New Model Introduction

New model GR-6400-000 is offered as a direct replacement for model GC18206A. Models have common mounting and tooling and are dimensionally the same.

GR-CUSTOM III SDG

Gen 5 Model GR-6400-000 (7511606-1)

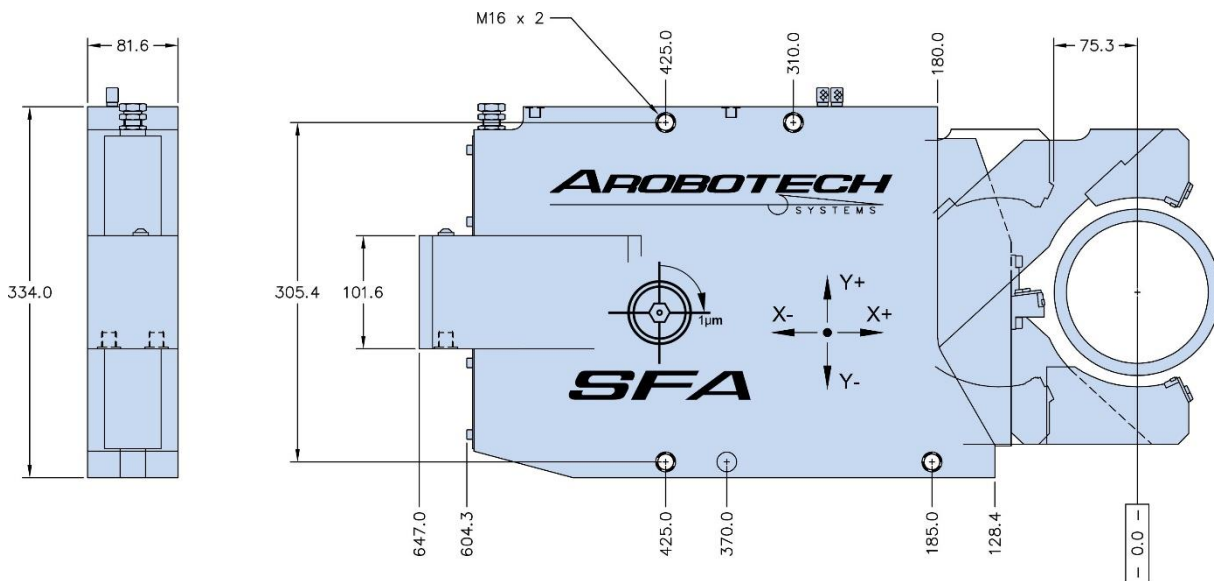
- * Max Clamp Size = 172mm Diameter
- * 38.3 cm² Piston Area
- * 90° Turn = 0.001mm Adjustment (both axis)
- * +/- 0.200mm Total Adjustment (both axis)

- * Max Clamp Size = 172mm Diameter
- * 38.3 cm² Piston Area
- * X-Axis = 3.1° Turn = 0.001mm Adjustment ▪ ±0.22mm Total Adjustment
- * Y-Axis = 10.4° Turn = 0.001mm Adjustment ▪ ±0.07mm Total Adjustment
